**ROCKFORD BOARD OF EDUCATION
INVITATION FOR BID ON SUPPLIES, MATERIALS, EQUIPMENT OR SERVICES
FOR SCHOOL DISTRICT NO. 205
ROCKFORD, ILLINOIS**

IFB No. 22-23 HVAC & Roofing Projects at Lincoln, East, Washington & Flinn Schools

RE: **ADDENDUM NO. 9**

A2.01B

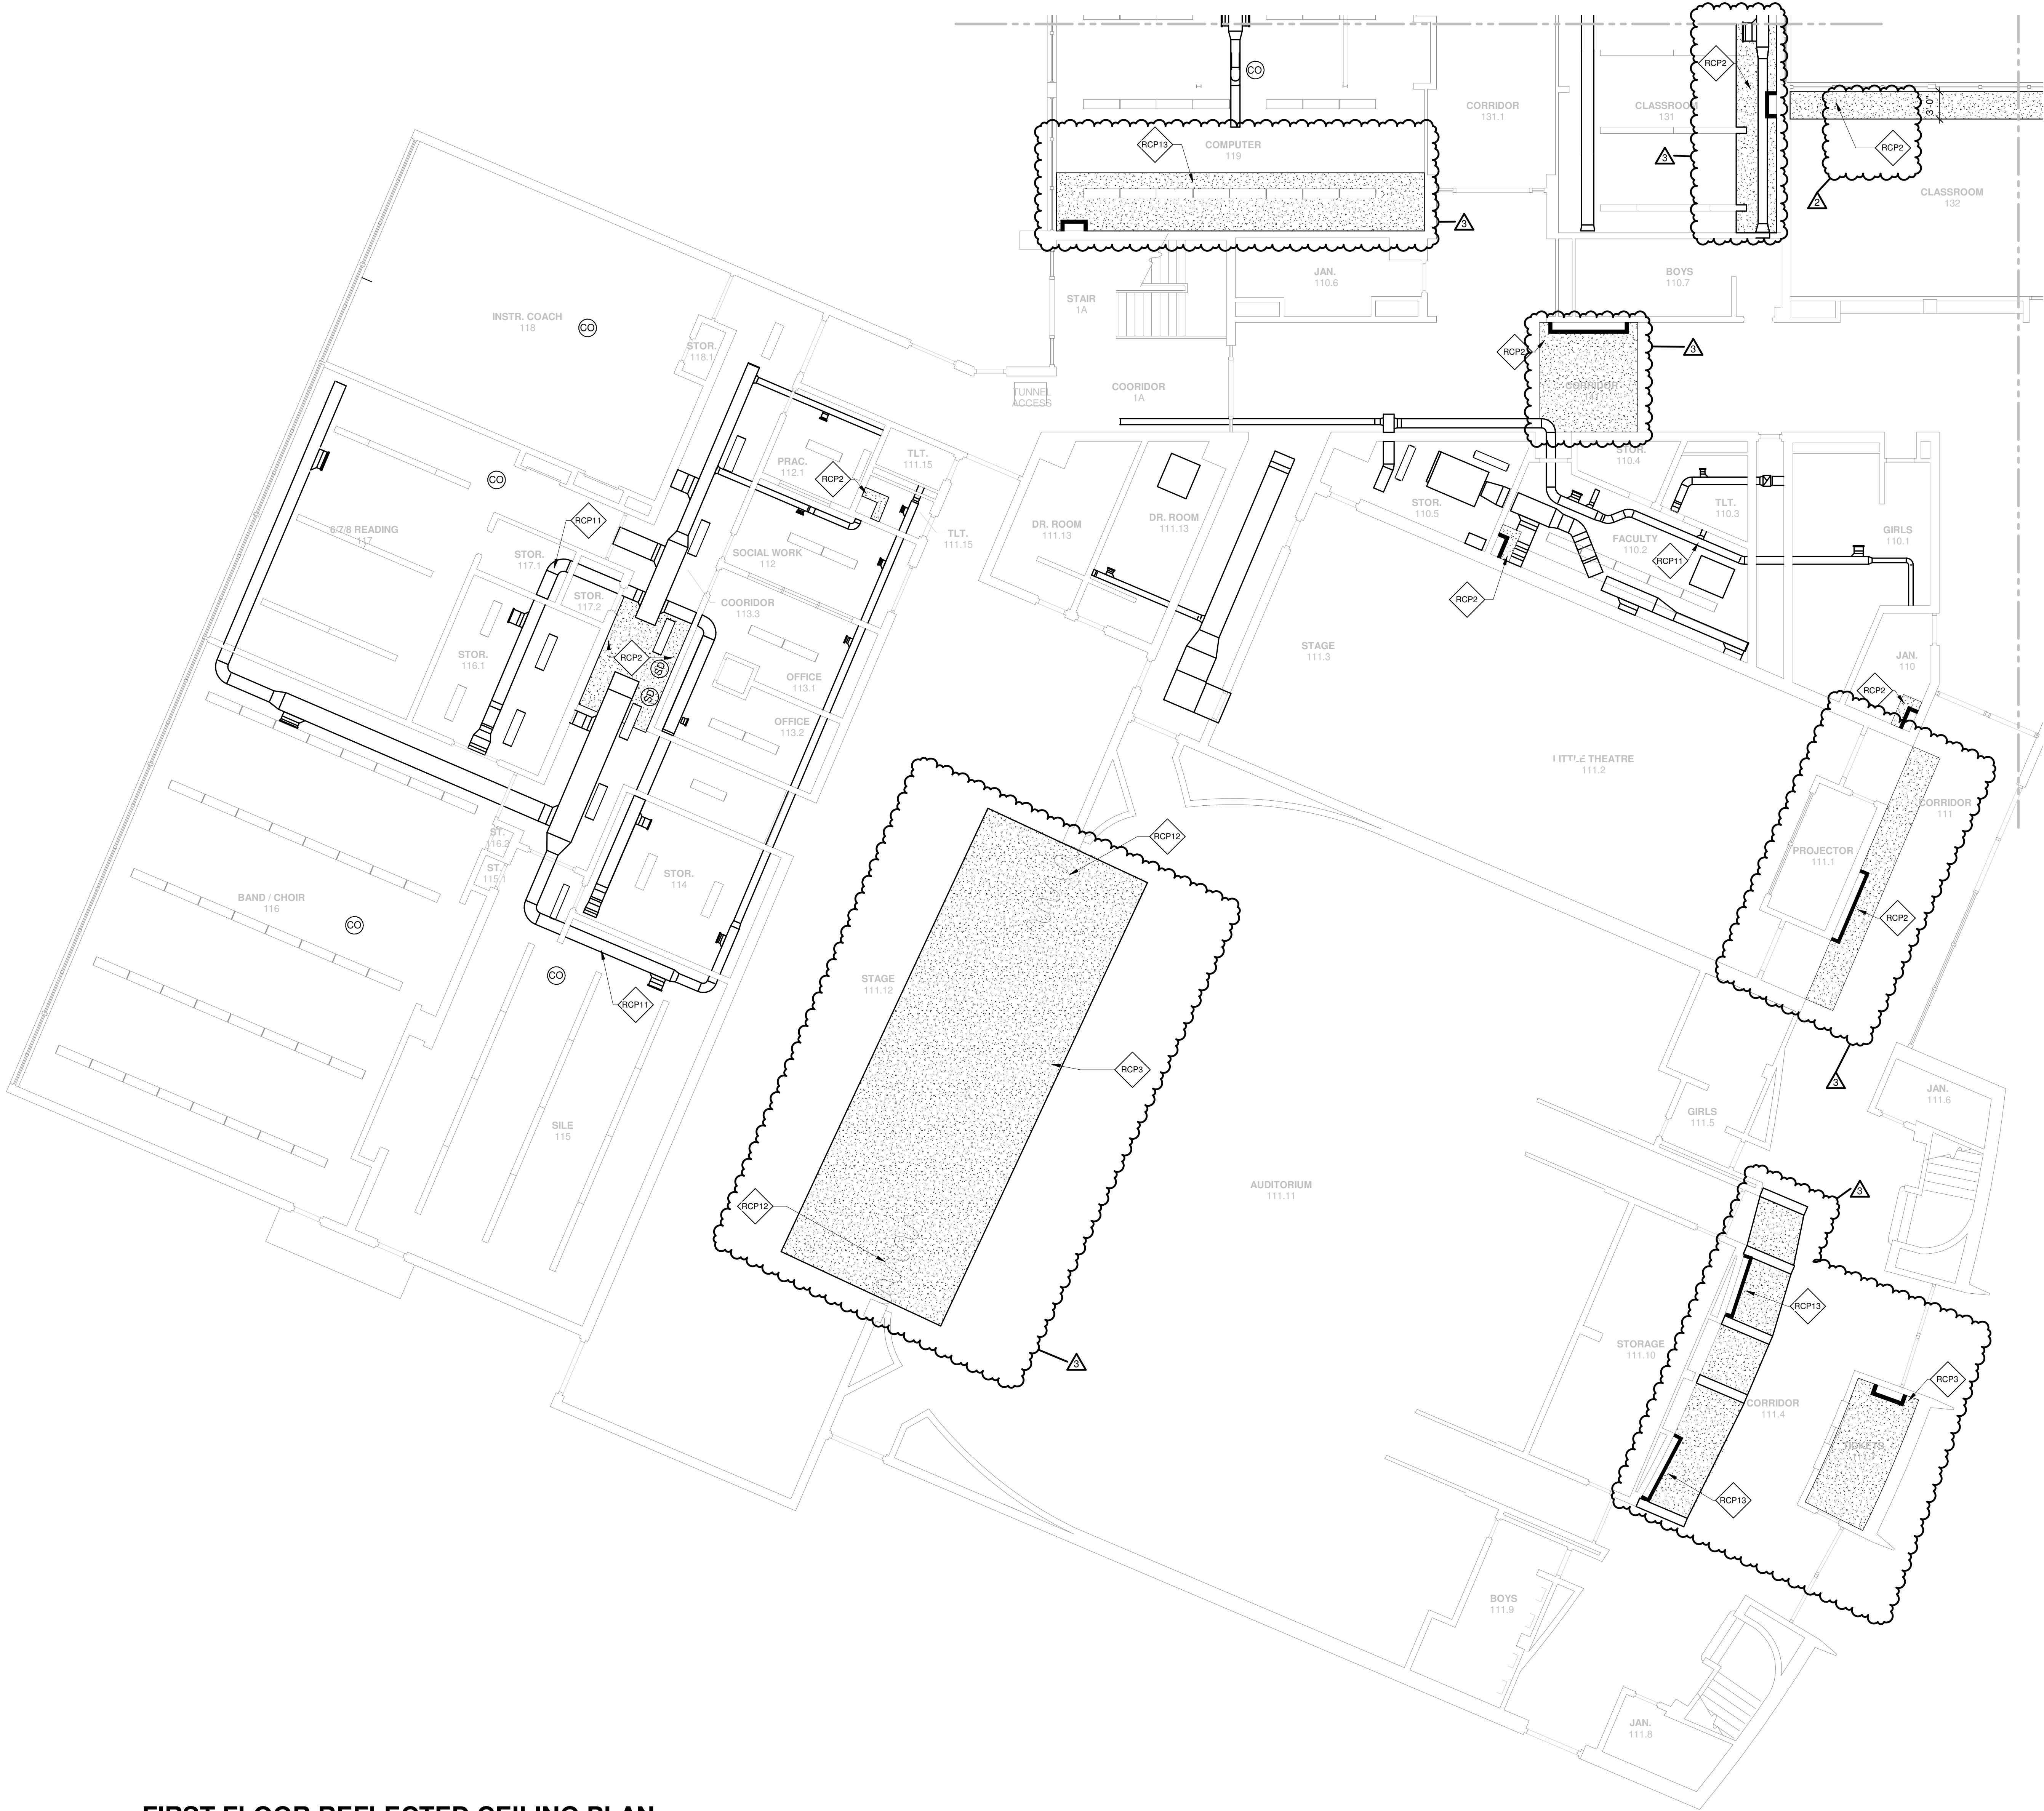
22. DRAWING A2.01B – FIRST FLOOR REFLECTED CEILING PLAN - AREA B & C
REPLACE entire sheet A2.01B – FIRST FLOOR REFLECTED CEILING PLAN - AREA B & C dated 03/10/2022

- a. **REVISE** note RCP2 "Existing plaster ceiling to be patched, prep and paint with gypsum board system. Provide a clean expansion joint between existing plaster ceiling and new gypsum board. Refer to detail 2/A2.02A", to read as follows "Existing plaster ceiling to be patched, prep and with gypsum board system. Provide a clean expansion joint between existing plaster ceiling and new gypsum board. Provide acoustical ceiling panels. Refer to detail 2/A2.02A".

**FIRST FLOOR
REFLECTED
CEILING
PLAN - AREA
D**

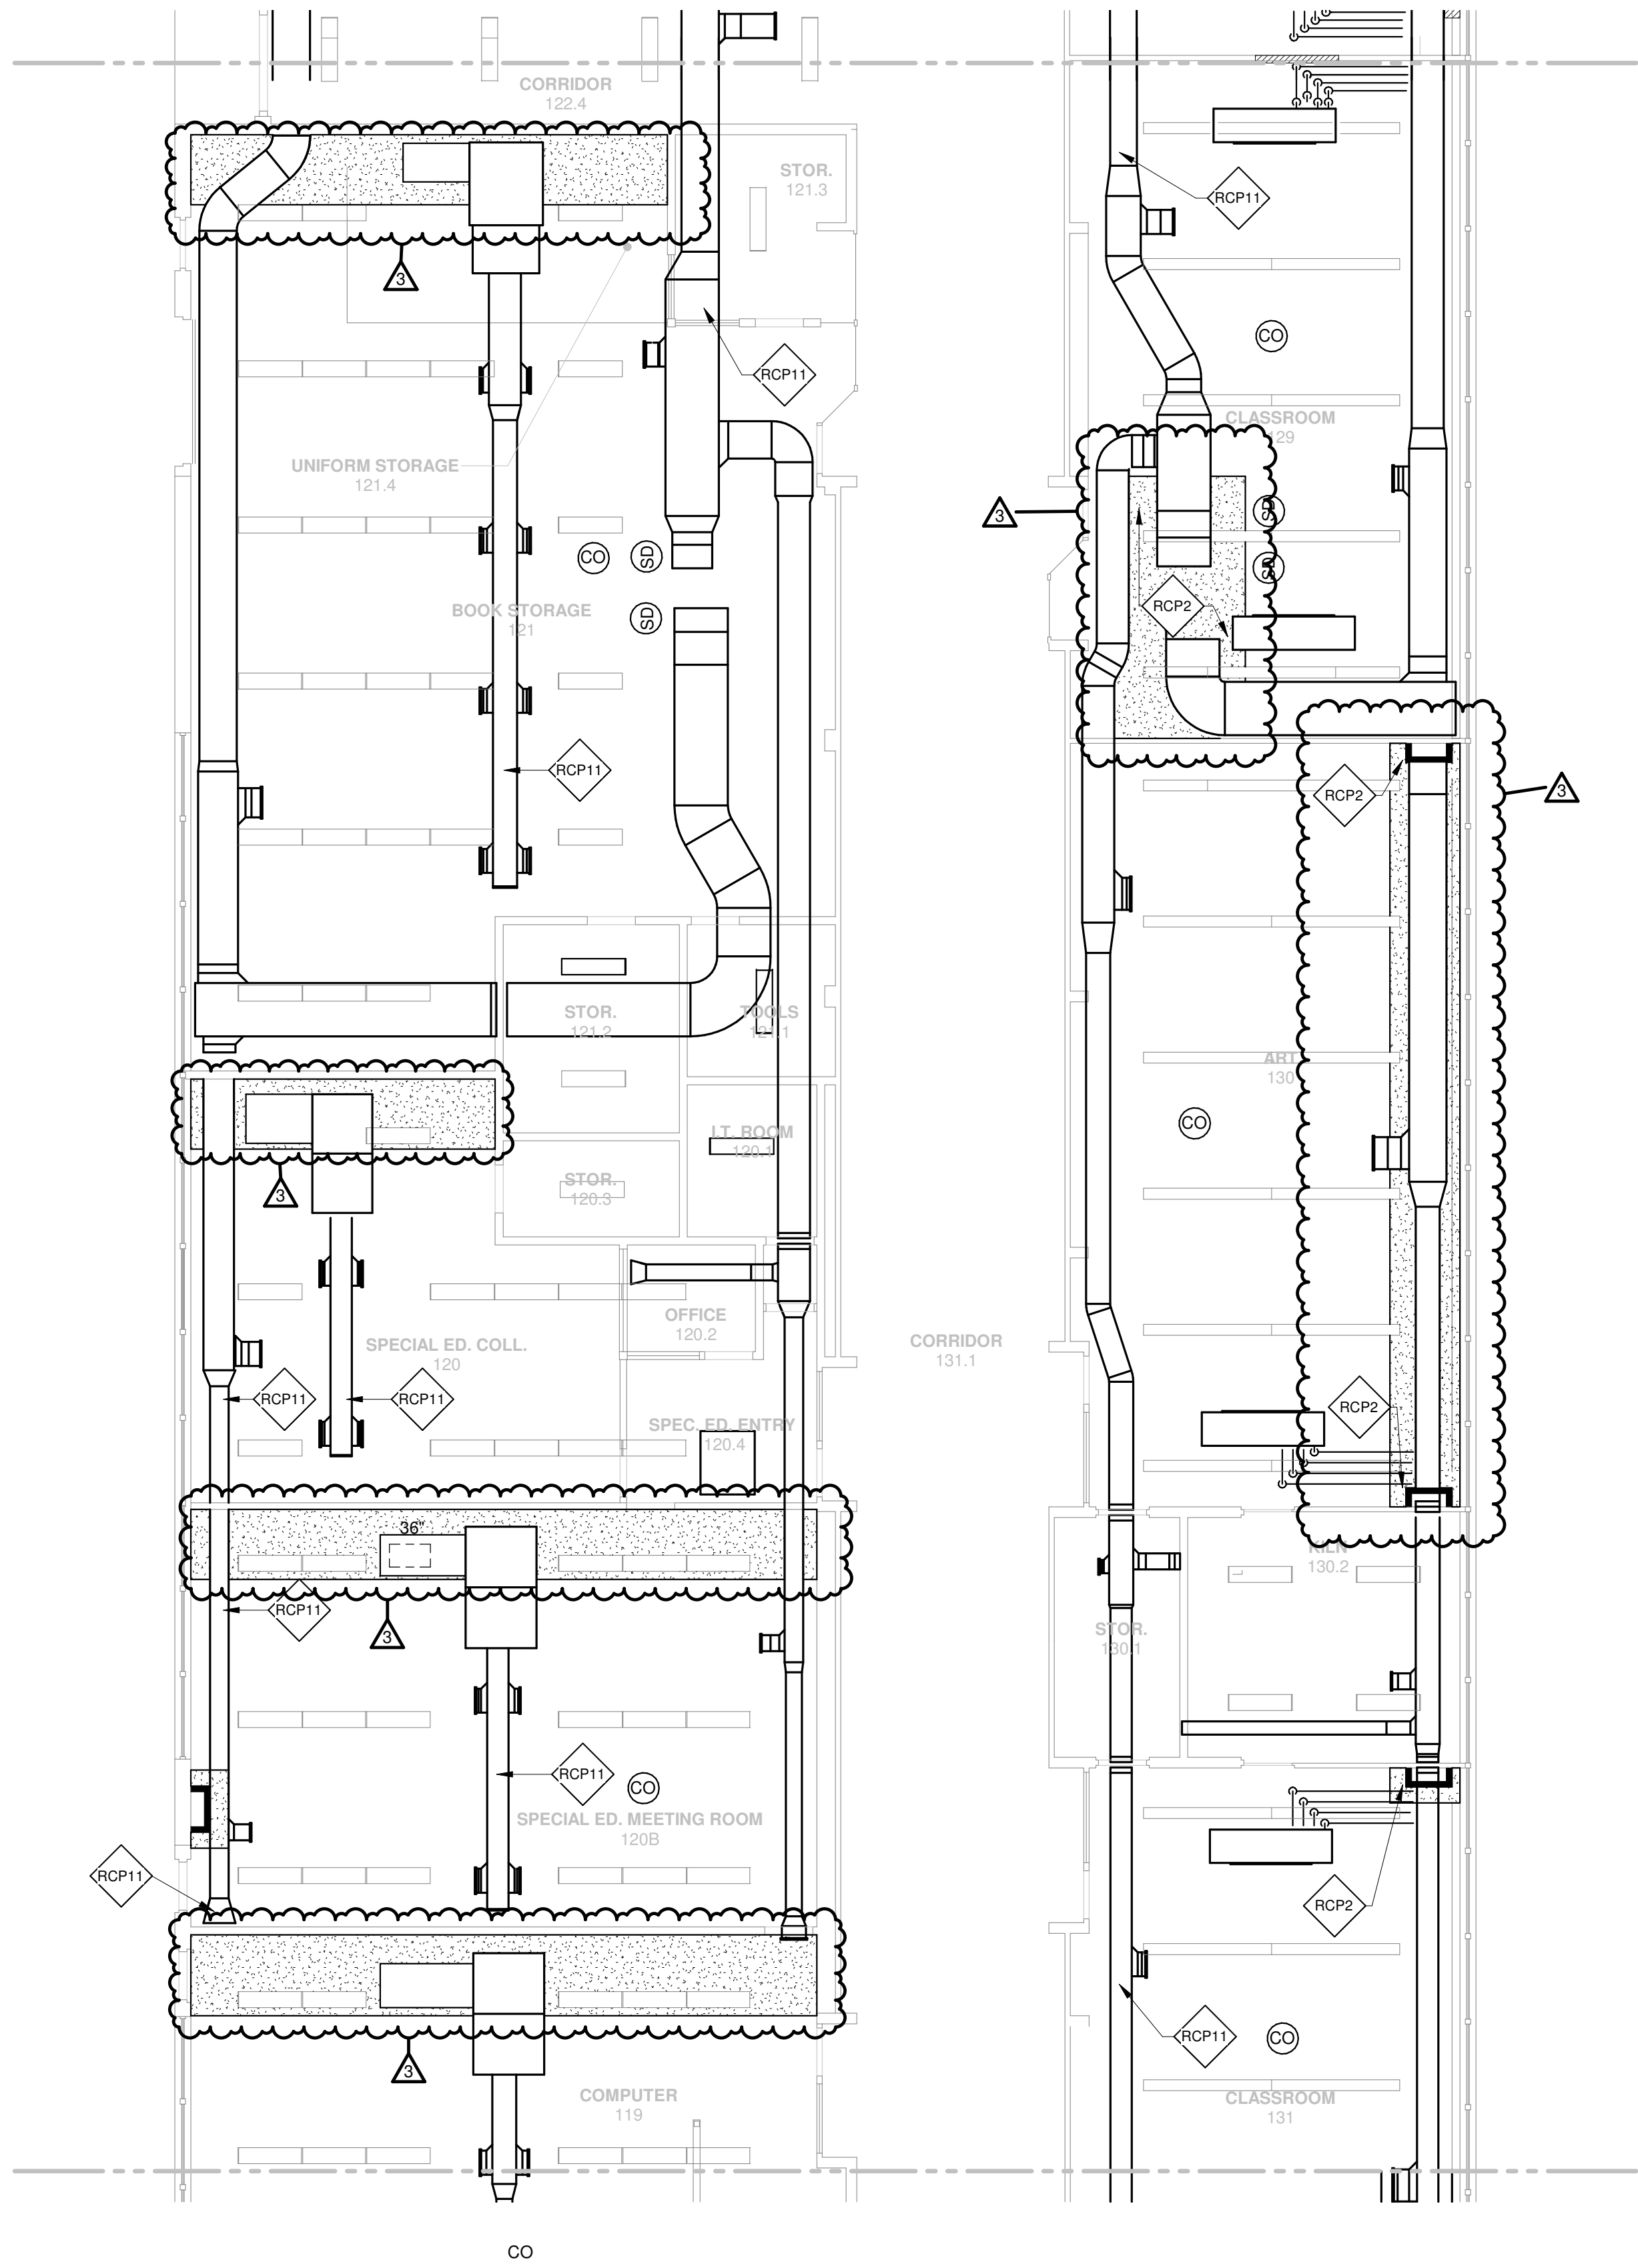
23. DRAWING A2.01D – FIRST FLOOR REFLECTED CEILING PLAN - AREA D **REPLACE** entire sheet A2.01D – FIRST FLOOR REFLECTED CEILING PLAN - AREA D dated 03/10/2022.

- a. **REVISE** note RCP2 "Existing plaster ceiling to be patched, prep and paint with gypsum board system. Provide a clean expansion joint between existing plaster ceiling and new gypsum board. Refer to detail 2/A2.02A", to read as follows "Existing plaster ceiling to be patched, prep and with gypsum board system. Provide a clean expansion joint between existing plaster ceiling and new gypsum board. Provide acoustical ceiling panels. Refer to detail 2/A2.02A".
